## Contract Routing Form

Project: State St Reconstruction Assessment District-2014

Contract No.: 7206  
Enactment No.: RES-14-00333  
Dollar Amount: 4,733,488.80

1 TREE PLANTING  
PL6 1"=1'-0"

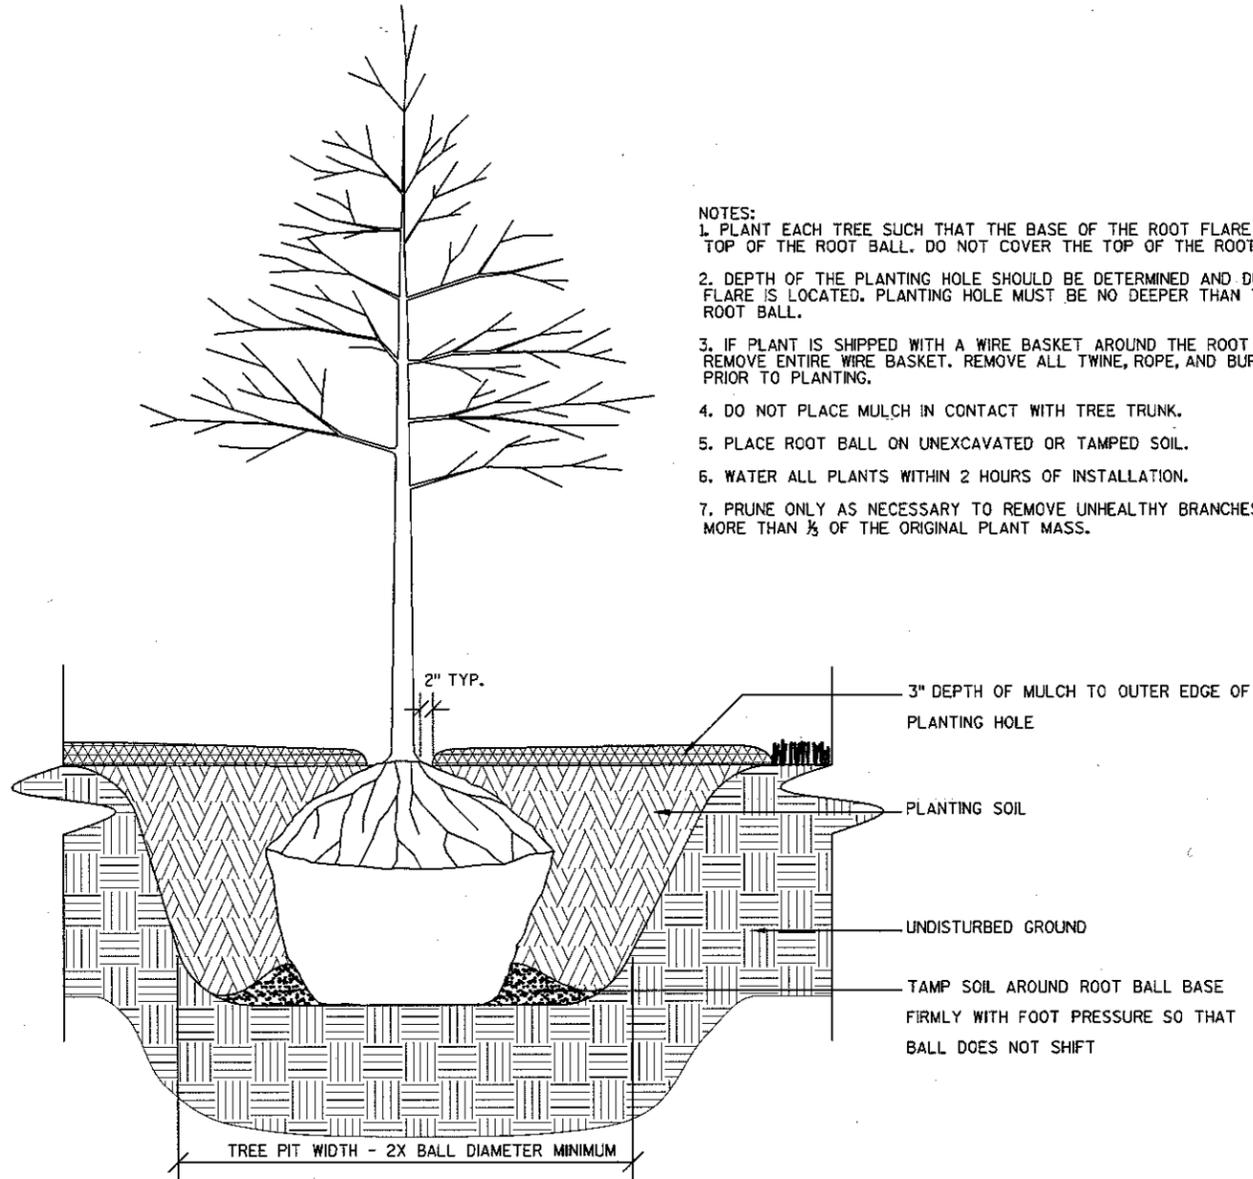
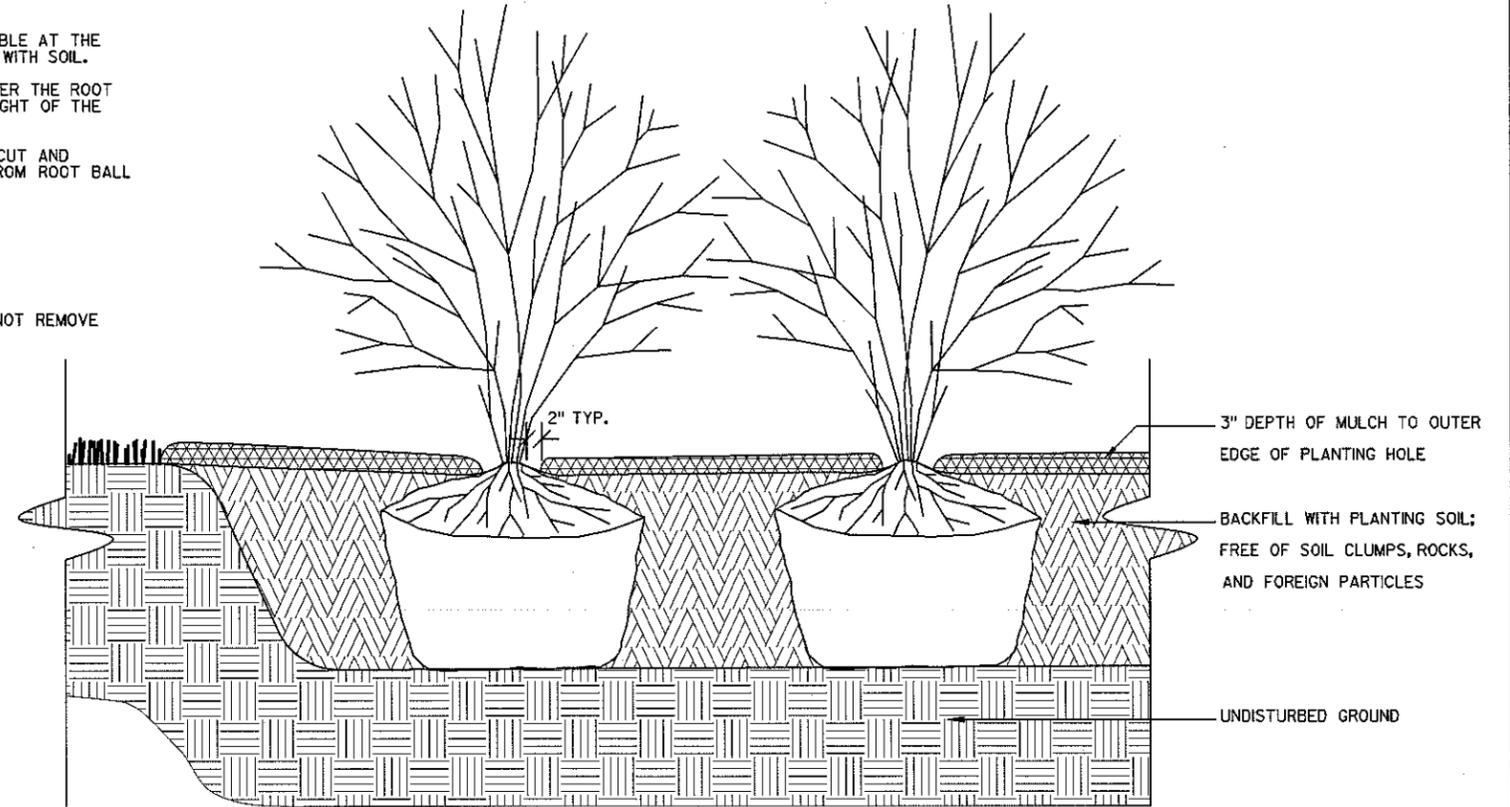
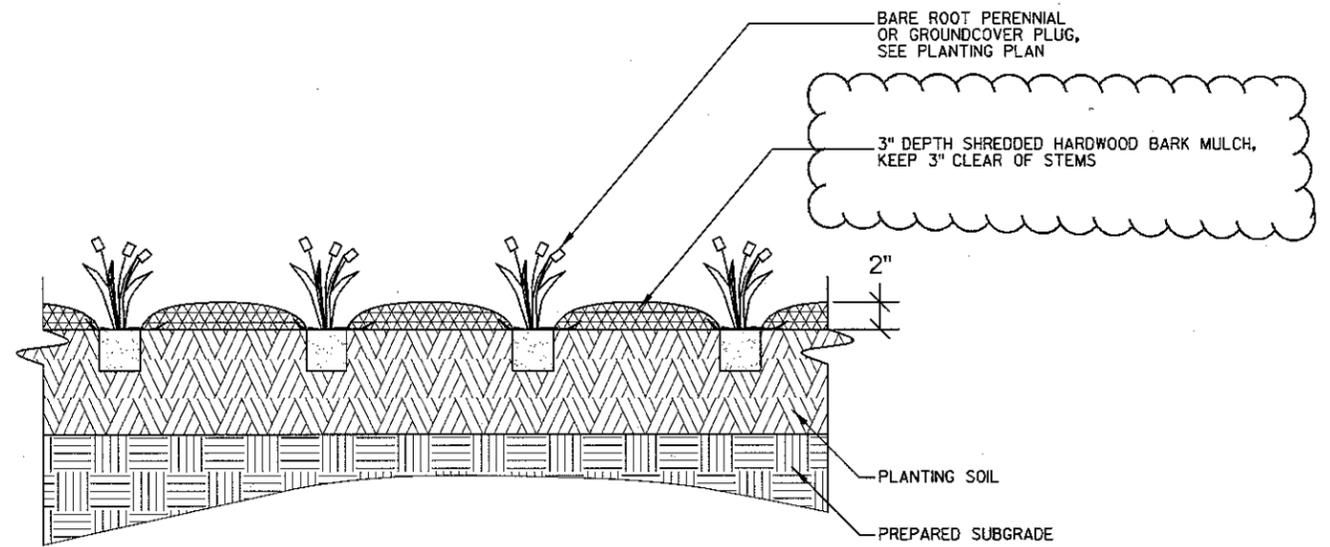
Replace Sheet PL6 (Revised 3/18/14) – Updated planting detail – added depth of mulch (3”).

Replace Sheet PL7 (Revised 3/18/14) – Updated tree planting detail – added Geotextile Fabric Type DF.

1 PLANTING PLAN - 800 BLOCK  
PL2 1"=20' @ 11X17

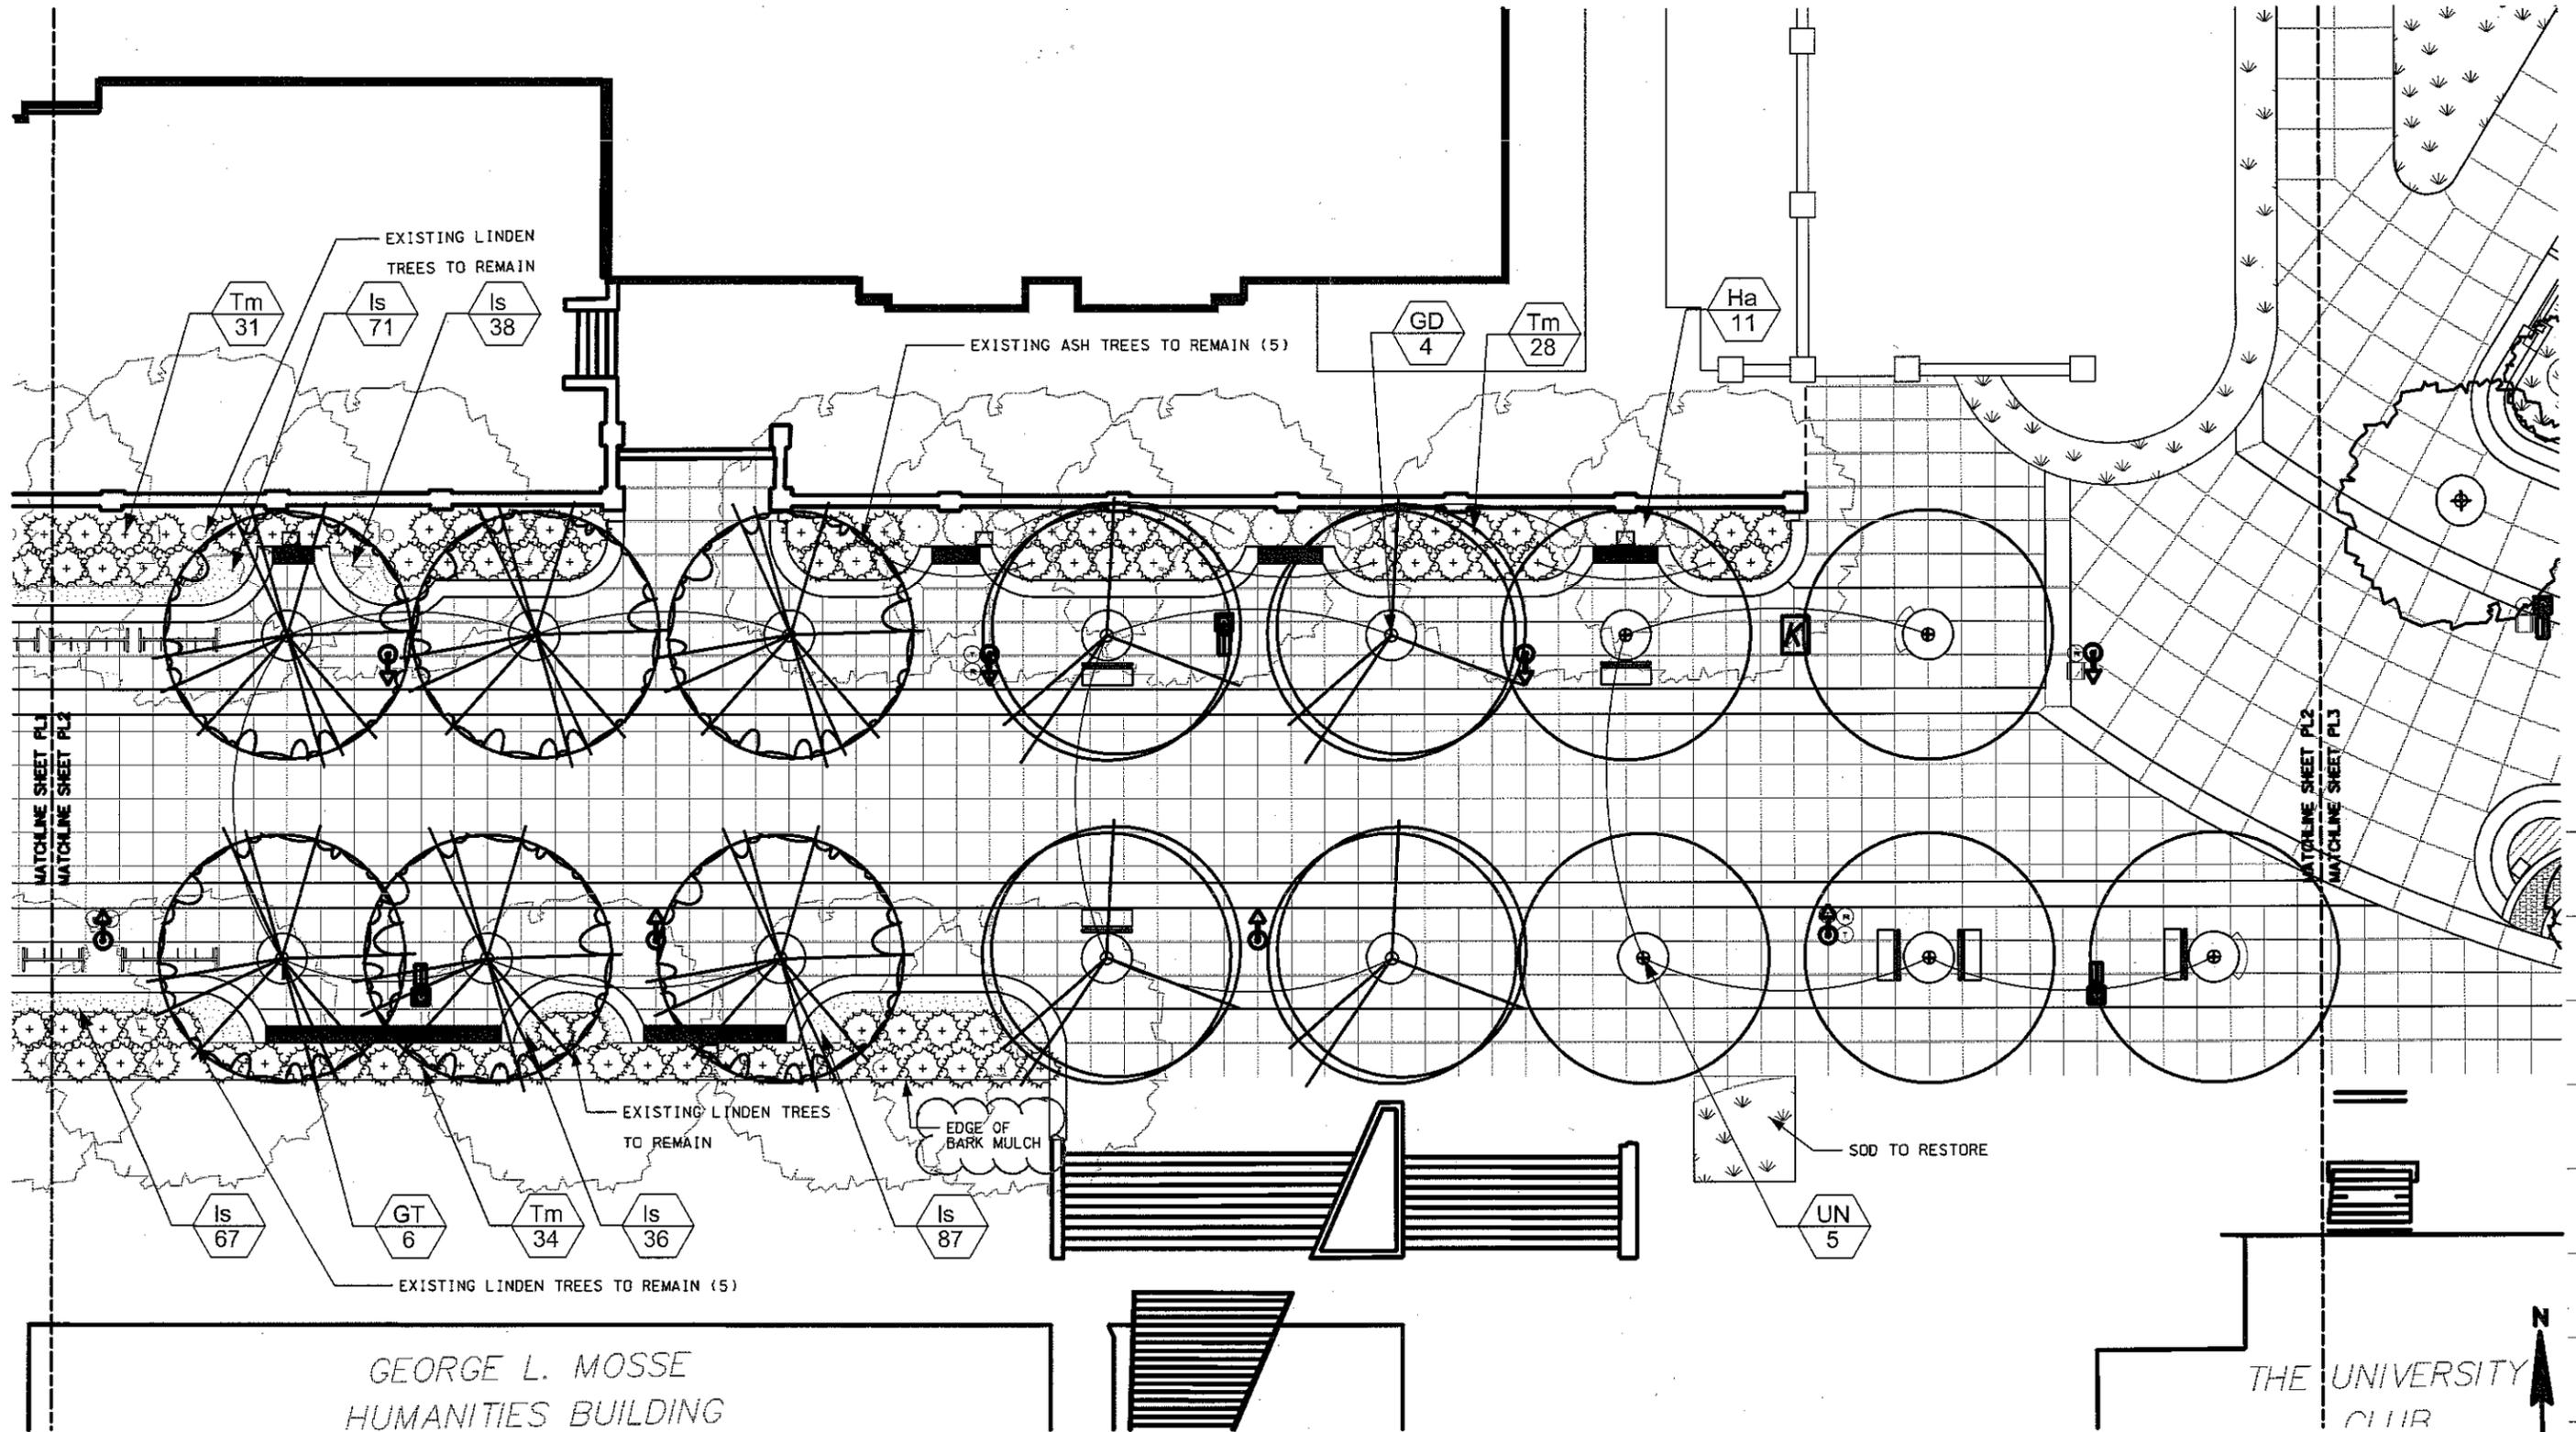
Replace Sheet PL2 (Revised 3/19/14) – Added limits for Bark Mulch item.

Revised 3/19/14 - Added Note
